Licence Number	L8980/2016/1
Licence Holder	Yeeda Pastoral Company Pty Ltd
ACN	094 819 717
File Number:	DER2016/001234-1
Premises	Yeeda Station Liquid Waste Facility Being a portion of Lot 268 on Plan 220707 WILLARE WA 6728
Date of Report	14/10/2019
Decision	Licence amended

2. Amendment Description

This amendment is made pursuant to section 59 of the *Environmental Protection Act 1986* (EP Act) to amend Licence L8980/2016/1 granted to Yeeda Pastoral Company Pty Ltd (the Licence Holder) for its Yeeda Station Liquid Waste Facility (the Premises).

Figure 1: Yeeda Liquid Waste Facility Premises layout

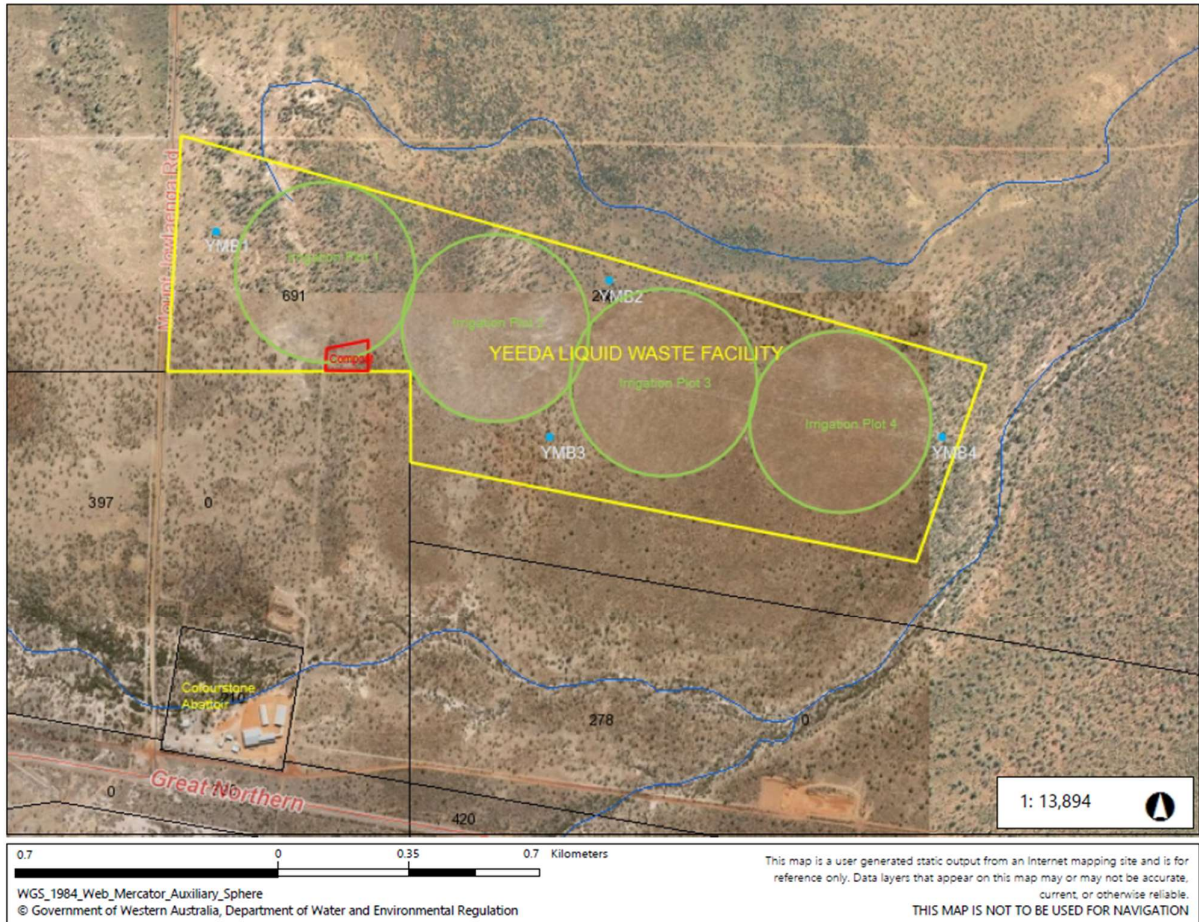
The requested changes in relation to the composting process are considered by the Delegated Officer to present a potential change to the risk profile of emissions and discharges from the Premises and, as such, have been considered in a revised risk assessment (Table 8) in accordance with DWER's published Regulatory Framework. In addition, the 'as constructed' location of the Compost pad on the Premises has been updated on the Premises maps shown in this Amendment Report (Figure 1) and in Schedule 1 of the Revised Licence.

Manure generated from the lairage pens at Colourstone Abattoir is dewatered in a sump adjacent to the abattoir and then transported via an internal road to the Compost pad at Yeeda Station, located adjacent to the irrigation plots (Figure 1). Around 1,100 tonnes per year of cattle manure is received at the Premises for composting.

off the Yeeda Station pastoral lease, on adjacent land vested in Department of Planning, Lands and Heritage (Lot 397 on Plan 29396). The Licence Holder undertook works to remove that portion of the Compost pad from Lot 397 and provided updated coordinates for the revised location of the compost pad. DWER has therefore updated the Premises maps in the Revised Licence to reflect the updated location of the Compost pad.
